Design Review Subcommittee (DRSC)

Meeting Date: September 9, 2015

SUBJECT: **MCUP 15-111 / MCHP 15-112, Tamarindo Restaurant**, a request to consider the remodel of a one-story commercial building and beer and wine for two future restaurant uses at 108-110 South El Camino Real.

Table 1 - DRSC concerns and project modifications

ATTACHMENT A

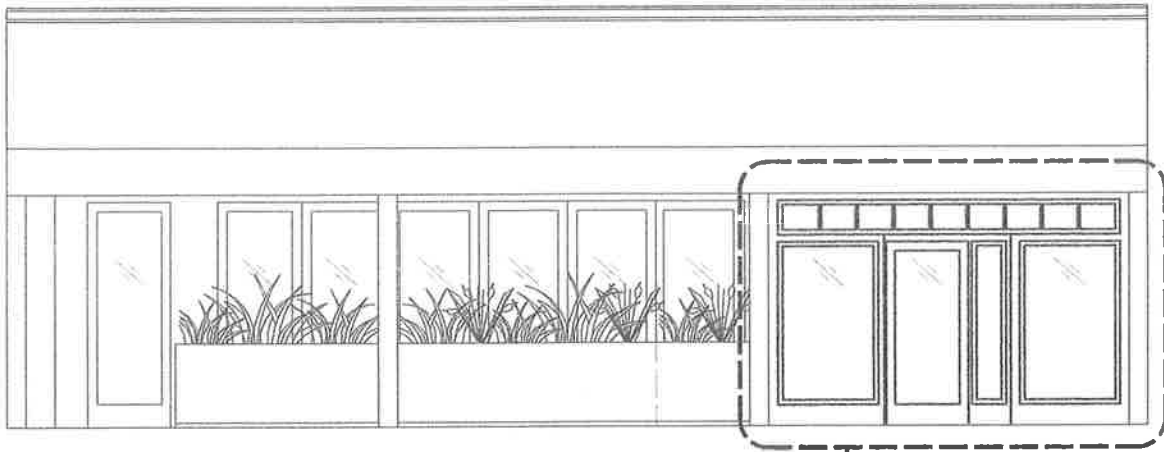
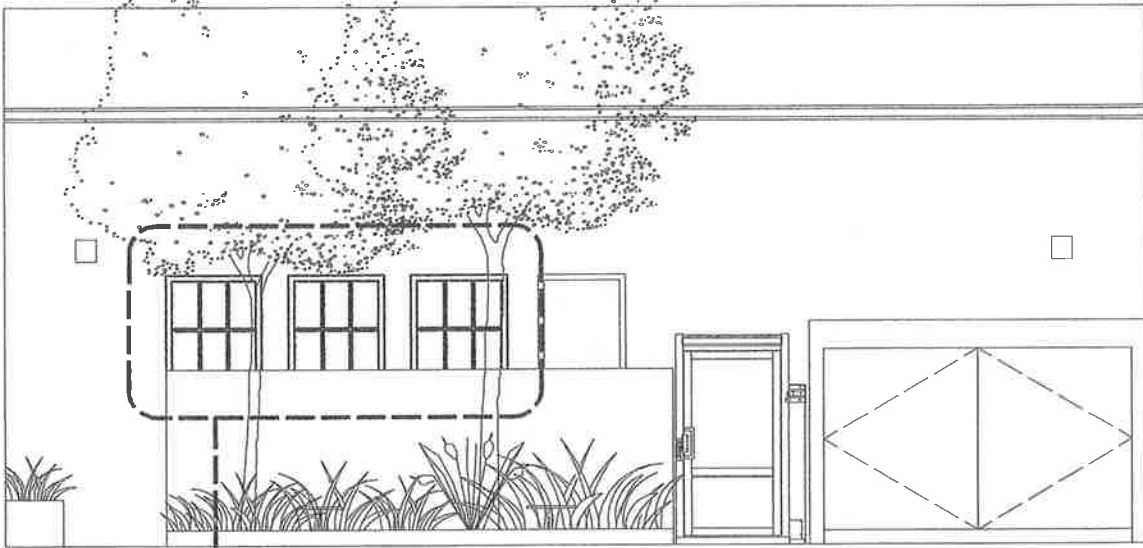
3. Wood doors/windows should be provided along the front elevation and they should have lites. Steel door and aluminum windows at the rear are acceptable provided their finish and detailing is consistent with a wood door/window. Steel door and aluminum windows should have traditional profiles and recessed. Aluminum windows should have lites. The bi-folding doors do not need to have lites.	<i>Modified as requested.</i> Wood doors/windows are proposed along the front elevation. Lites have been added to the west storefront. The aluminum windows at the rear now include lites and are recessed six inches. The steel door is recessed six inches.

1. In response to DRSC comments, Applicants have revised the proposal to include genuine lites on the windows fronting the alleyway and in the storefront of the small take-out restaurant space. These are consistent with the illustrations provided in the Henry Lenny Design Guidelines. Please see attached revised elevation drawings (Attachment A).
2. In response to DRSC comments, the Applicants have revised the proposal so that the wheelchair lift in the rear of the building, required under California Building Code and the Americans with Disabilities Act, and the trash enclosure, as required by San Clemente Municipal Code, will be powder coated in a standard bronze color (Tiger Drylac

[REVISED] WOOD WINDOWS WITH LITES

[REVISED] ALUMINUM WINDOWS WITH LITES

[REVISED] LITES AT FRONT STOREFRONT WINDOW AND REAR SERVICE ENTRY

ATTACHMENT B

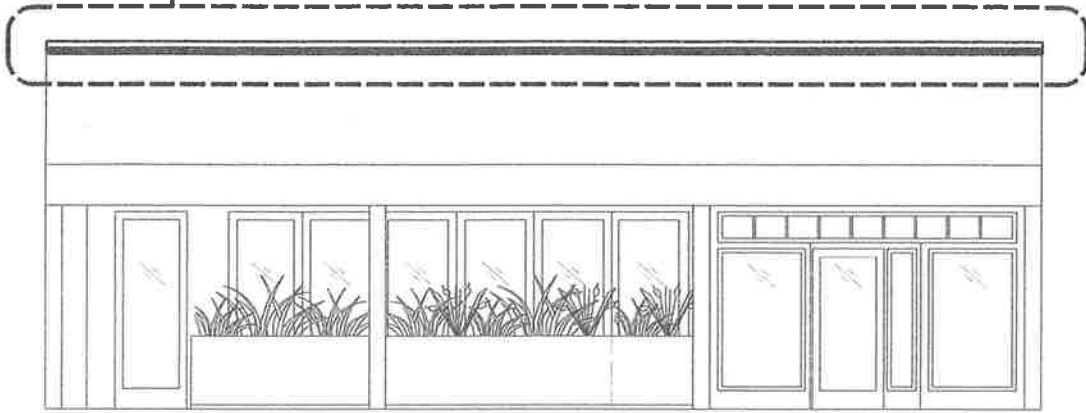
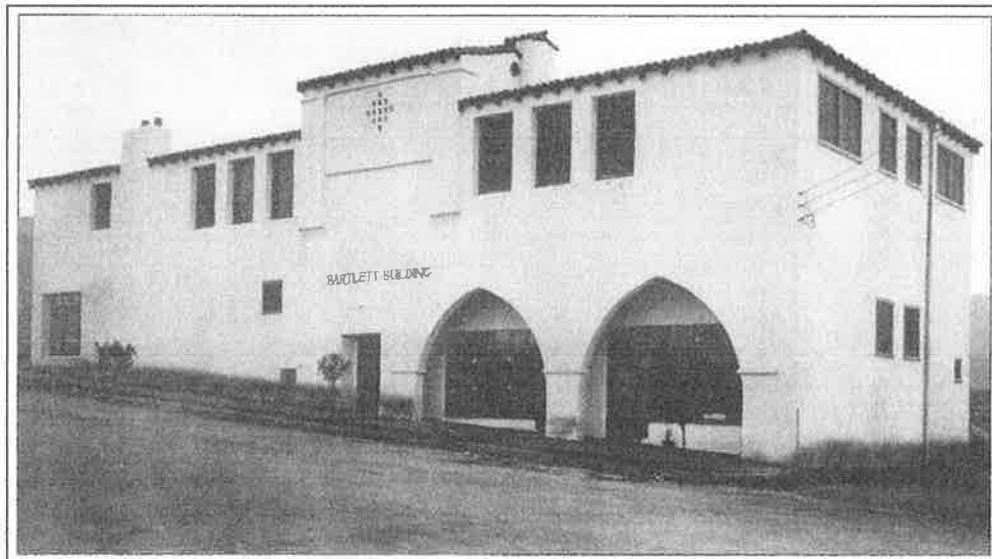
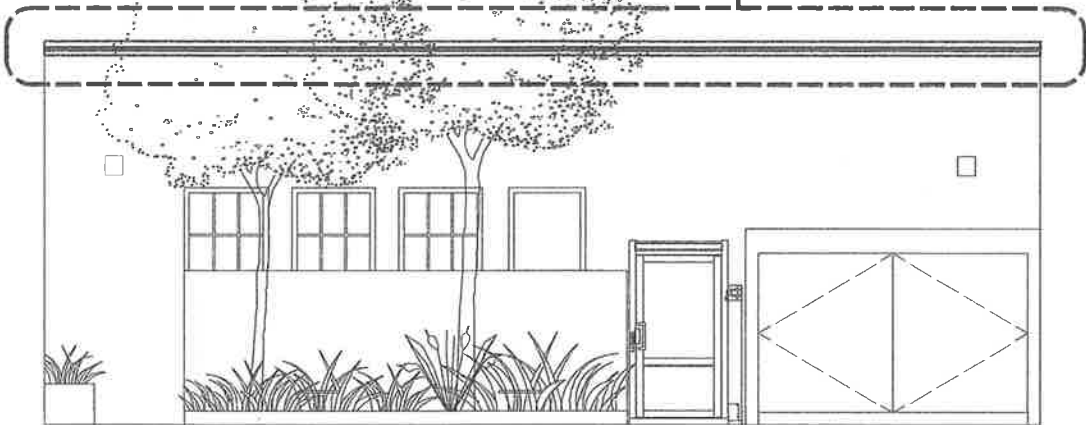
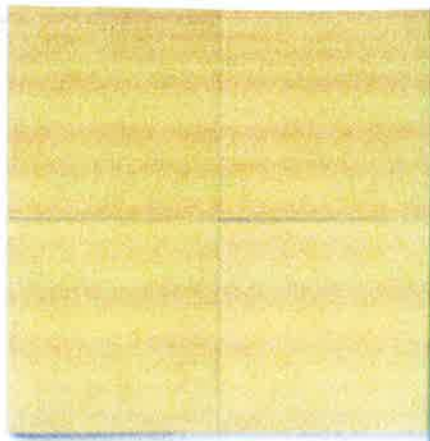
2. A cornice detail should be added to the front and rear parapets. Cornice detail should be simple in design.	<i>Modified as requested.</i> A cornice detail has been added to the front and rear of the building.

3. In response to DRSC comments, the Applicants have included a cornice detail on the front and rear facades. This detail is borrowed from and contextual to the Avenida Del Mar facade of the Bartlett Building. Please see attached drawing (Attachment B).

[N] CORNICE DETAIL

[N] ADDITION OF CORNICE DETAIL AT FRONT AND REAR PARAPETS

ATTACHMENT C

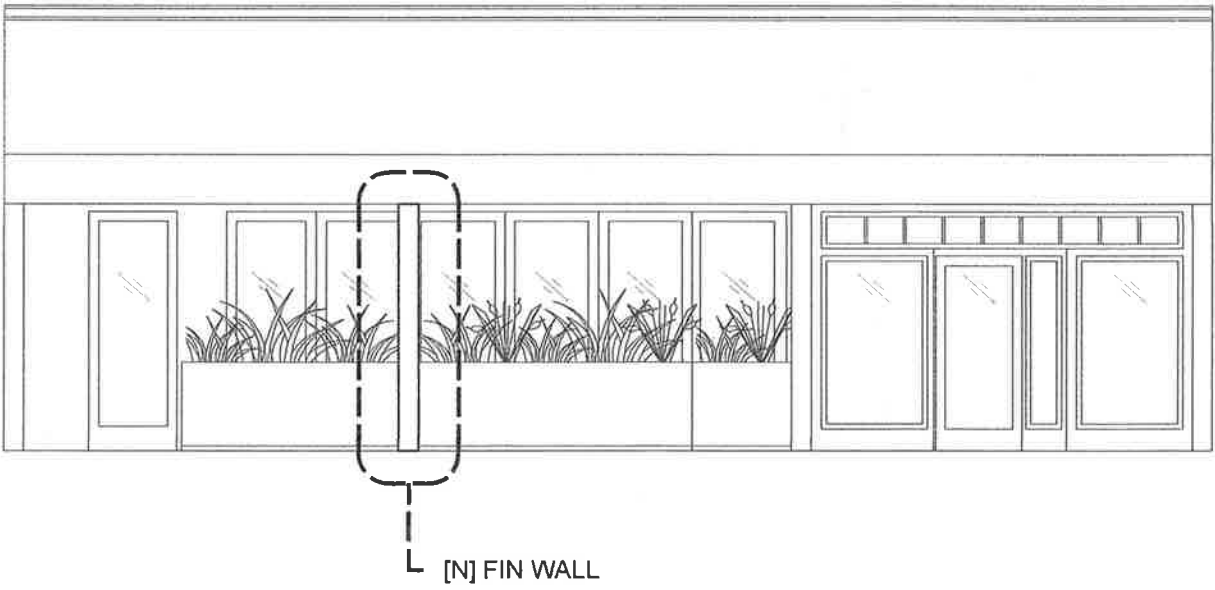
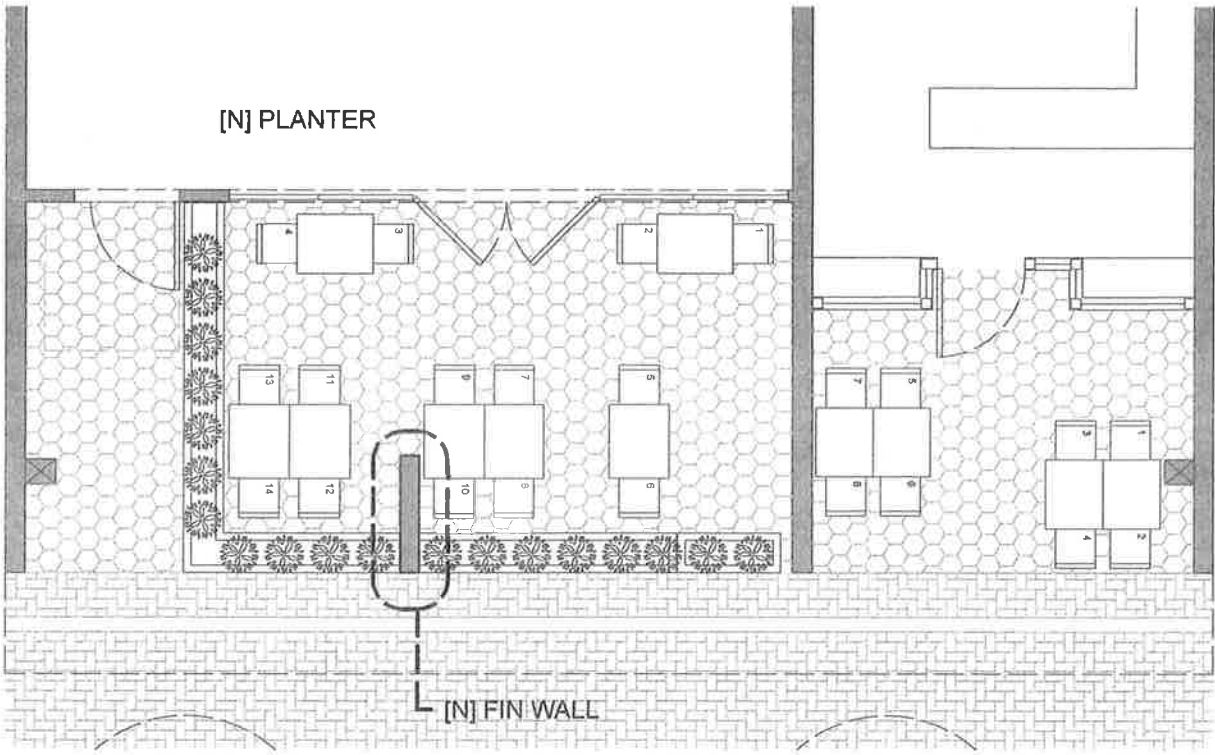
DRSC Concerns	Project modifications
<p>6. Staff recommends terra cotta paver flooring for the front courtyard. The cement tile flooring is a less traditional application and is more appropriate for the rear alley façade where it will have less visibility.</p>	<p>Modified. Cement floor tiles are proposed along the front elevation in a color and shape that match those at the Casa Romantica.</p>
<p>7. Traditional wrought-iron lighting should be provided for the project. Recessed lighting within courtyard canopy and outdoor patio floor is a modern design, not a traditional Spanish Colonial Revival feature and should be eliminated.</p>	<p>Modified. The recessed floor patio lighting was eliminated. Applicant requests to maintain and expand upon the existing recessed canopy lighting.</p>
<p>8. Traditional wrought-iron should be utilized for rear service entry handrails.</p>	<p>Unclear. Material of handrail is not specified on the plans.</p>

4. In response to DRSC comments, the Applicants have removed the proposed gooseneck signage lighting from the front of the building.
5. In response to DRSC comments about not "San Clemente" colors, the Applicants have revised the front cement (encaustic) tiles to identically match the colors in the cement tiles original to Casa Romantica. The shapes (hexagon and squares) are also identical to those tiles found at Ole Hanson's home. The edge pattern proposed is a traditional Spanish Colonial Revival pattern and matches one in Casa Romantica. Please see attached drawing (Attachment C). They have also changed the color of the porch wall in the back of the building to match the accent color of the Historic City Hall building (Dunn, Edwards DE5718). both a green color

[REVISED] TILE AT FRONT OUTDOOR DINING AREA

ATTACHMENT D

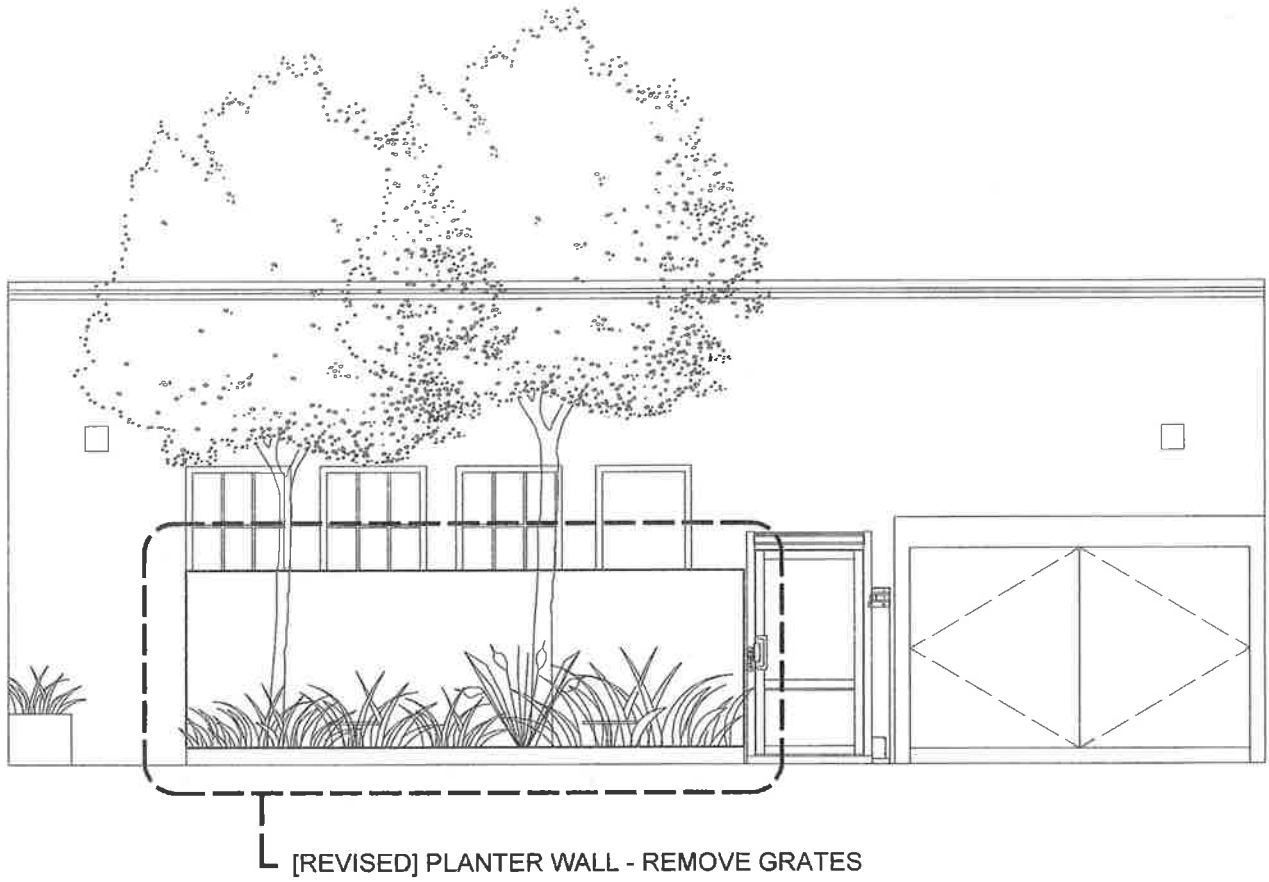
6. In response to Subcommittee Chair Crandell's request, the Applicants have added a fin wall to match those of the existing structure to produce a repetitive sequence of bays that have "a similar shape or feel to give a rhythm down the line." This returns the building to its original façade of three bays. Please see attached drawing (Attachment D).

[N] FIN WALL ADDED TO FRONT FACADE

ATTACHMENT E

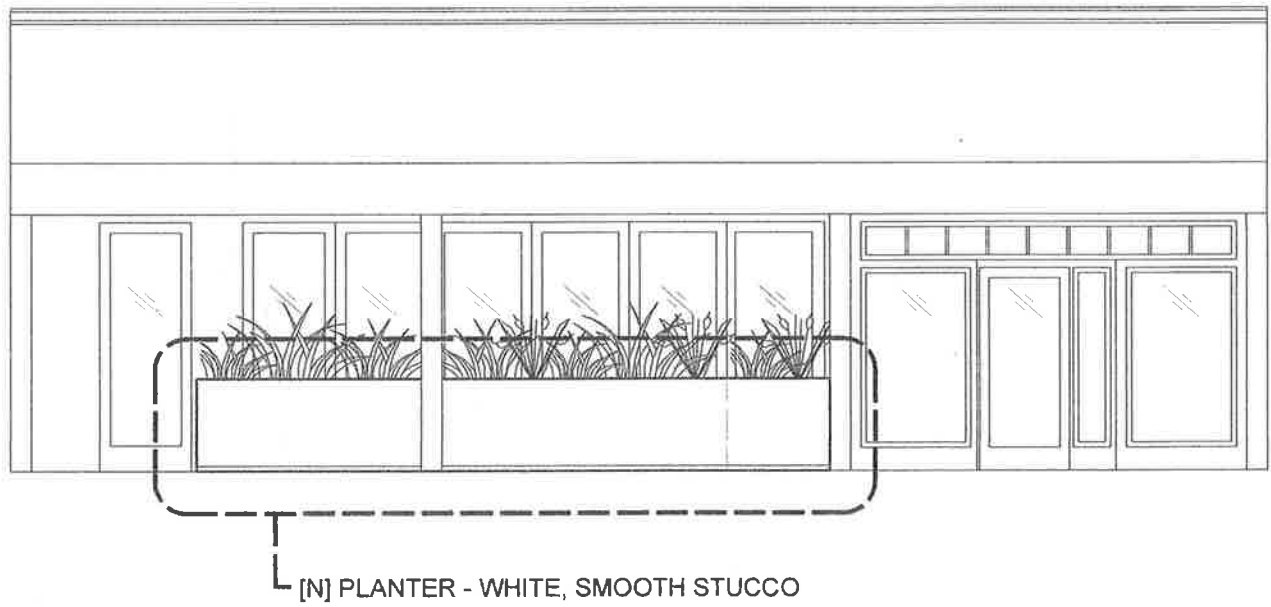
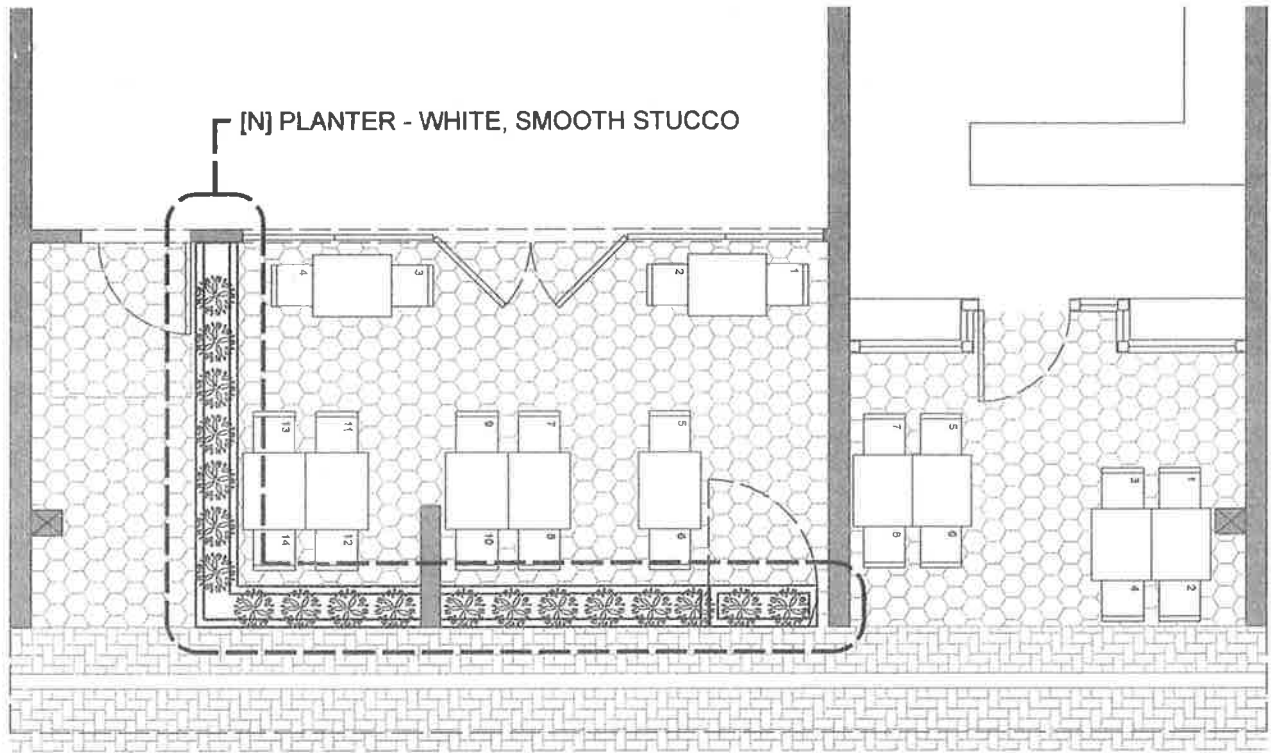
7. In response to DRSC comments, the Applicants have removed the stucco grates from the alleyway planter wall. Please see attached drawing (Attachment E).

[REVISED] PLANTER - REMOVAL OF GRATES

ATTACHMENT F

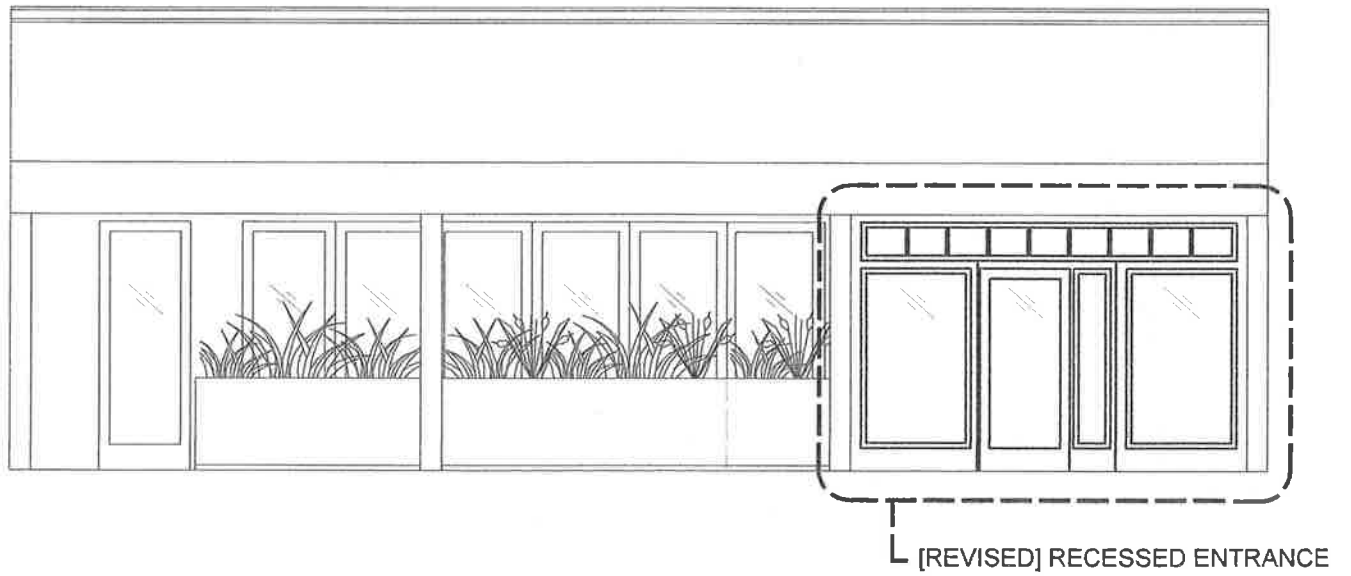
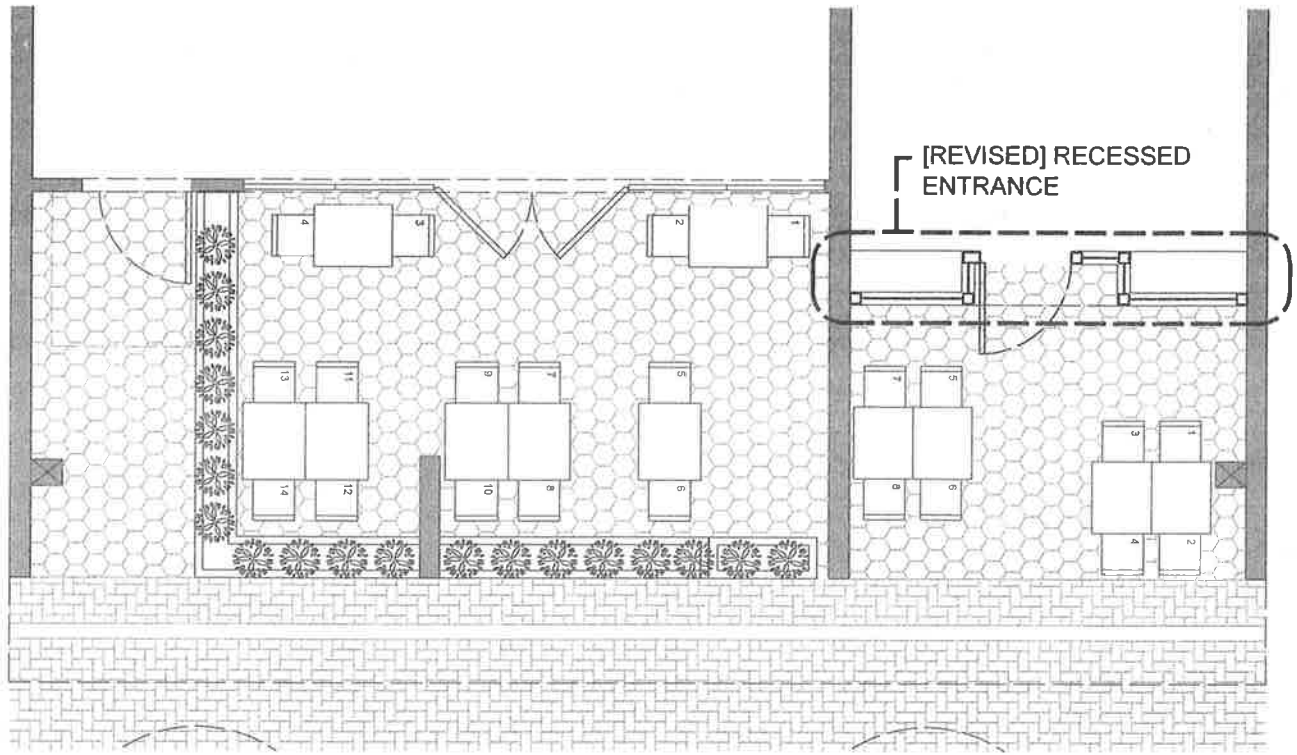
- Appreciated the open appearance of the front façade.
- Suggested the applicant reconsider the use of potted plants as a physical barrier between the outdoor patio and sidewalk. A more traditional application would be a low stucco wall or solid wrought iron fence.

8. In response to DRSC comments, the Applicants have removed the pots from the front of the building. In its place they have enclosed the outdoor eating area with a stucco planter along the front property line. Like the terra cotta pots originally proposed, the planter also meets California ABC standards regarding height and separation of eating areas from the public right-of-way. In response to concerns from the DRSC regarding beer and wine sales as part of a bona-fide restaurant, this planter also separates the restaurant entry from the eating area on private property and meets OC Sheriff's requirements for sightlines into the restaurant. The planter will be finished in smooth stucco, consistent with the Planning Department's directive. Due to requirements under the California Building Code, we have included egress under CBC Chapter 10. The plaster will be sealed with an anti-graffiti coating. The plants will be selected from the list provided in the Design Guidelines. The planter addresses the DRSC's concerns regarding the connection between sidewalk pavers, concrete strip, and matching sidewalk paving for the approximately 1-foot section of City property, as noted on the drawing. Please see the attached drawing (Attachment F). white color

[N] CALIFORNIA ABC PLANTER - WHITE, SMOOTH STUCCO
